N3383A-02A

S E R V I C E N O T E

N3383A PNA Microwave Network Analyzers

Figure 1: A3 Front Panel Interface Board Assy without the Bracket

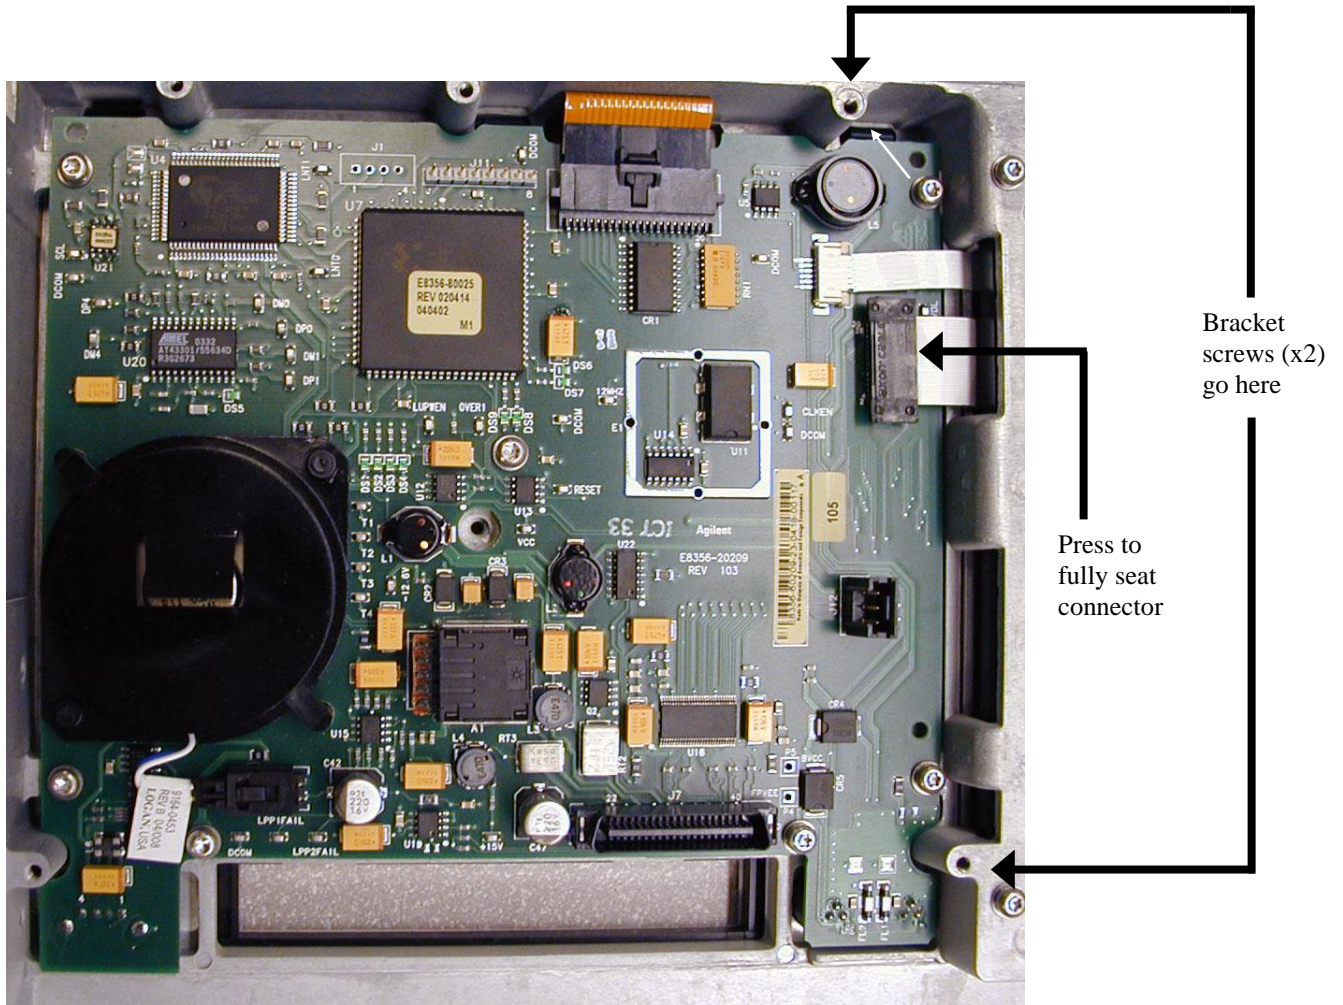
A connector of the ribbon cable (Agilent part number 8120-8409) that joins the front panel display to the front panel interface board can loosen, causing a display failure, unless a new bracket is installed. Because the failure rate has been very low, it is recommended that the bracket be installed only when there is an additional reason to remove the PNA front panel.

1. Refer to Figure 1 in this document:
 - Press down firmly on the ribbon cable's black connector.
 - Locate the two tapped holes for the bracket screws.
2. As shown in Figure 2 in this document, position the bracket so that its holes line-up with the two holes you located in the previous step.
3. Hand-start the two screws, and then torque both to 9 in-lbs.
4. Reinstall the PNA Front Panel by following the Service Guide instructions in the "Replacement Procedure." This is located on the same page as the "Removal Procedure" used previously in step 7.
